PERMIT

ON-SITE SEWAGE DISPOSAL SYSTEM HOWARD COUNTY HEALTH DEPARTMENT BUREAU OF ENVIRONMENTAL HEALTH

SUBDIVISION: Saddlebrook Farm

LOT NUMBER: 8

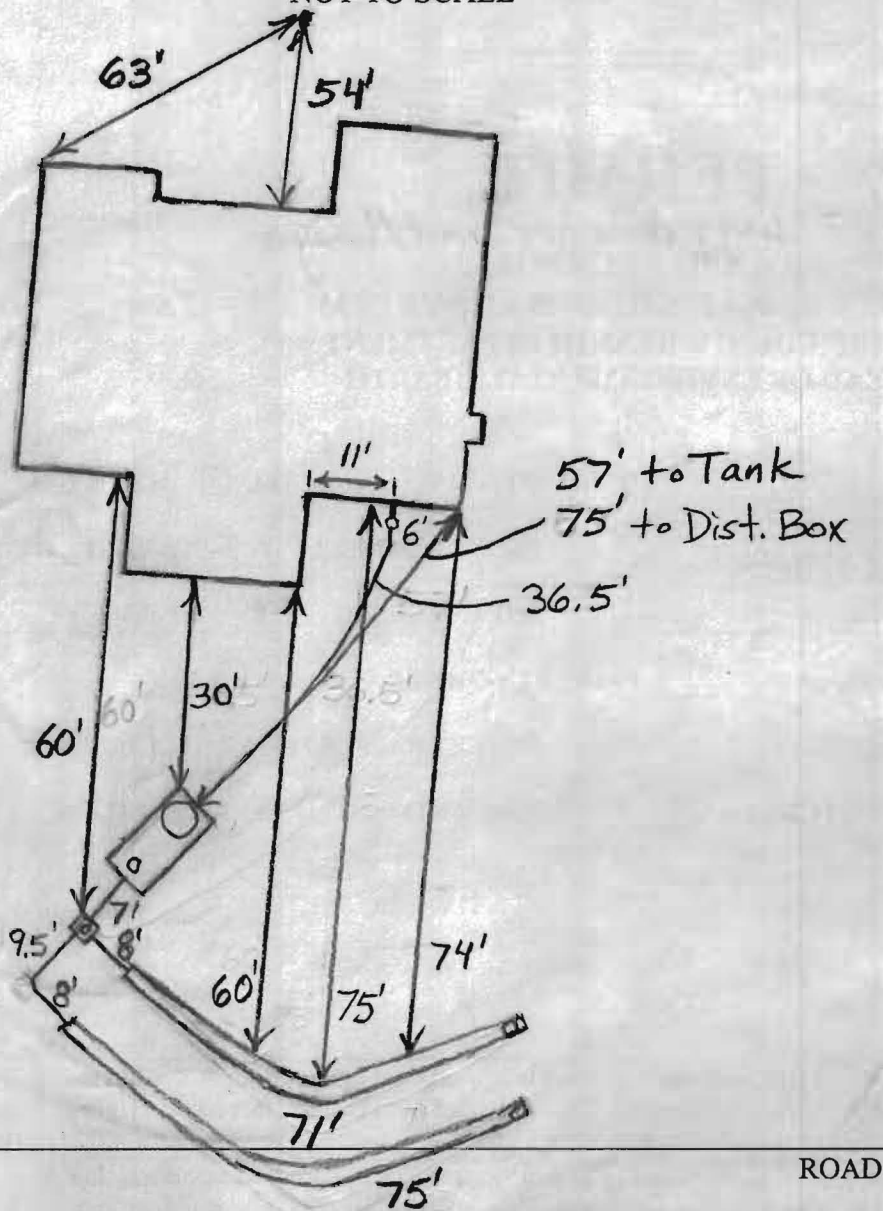
10/15/07 Easement not staked. Layout cancelled. (BB)

10/16/07 Trench locations painted in field. Installer to set distribution box as shown on plan and install 2-72' trenches toward lot 7 in highest part of easement. (BB) 10/17/07 System finished. O.K. to backfill. (BB)
